Product Change Notice (PCN)

PCN Number: **PCN-0450984R-01**

Product(s) Affected: SJ1-3533N, SJ1-3534N, SJ1-3535N

<p>PCB LAYOUT TOP VIEW</p>	 <p>Recommended PCB Layout Top View</p>

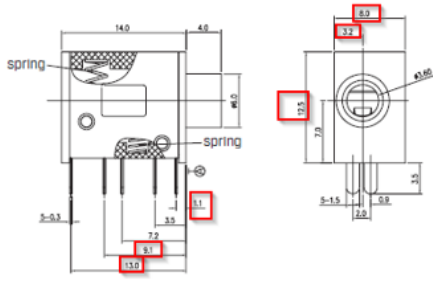
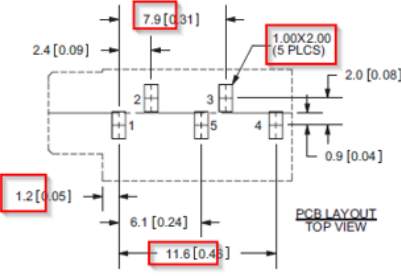
Description of Change: mechanical and material differences as shown below:

MATERIAL	PLATING
terminal 1	brass	tin
terminal 2	brass	tin
terminal 3	brass	tin
terminal 4	brass	tin
terminal 5	brass	tin
bushing	brass	nickel
spring	stainless steel	
plastic	PBT

DESCRIPTION	MATERIAL	PLATING/COLOR
terminal 1	brass t=0.30	silver
terminal 2	brass t=0.30	silver
terminal 3	brass t=0.30	silver
terminal 4	brass t=0.30	silver
terminal 5	brass t=0.30	silver
springs	stainless steel	
bushing	copper alloy (H59)	nickel
housing	PBT (UL94V-0)	black
cover	PBT (UL94V-0)	black
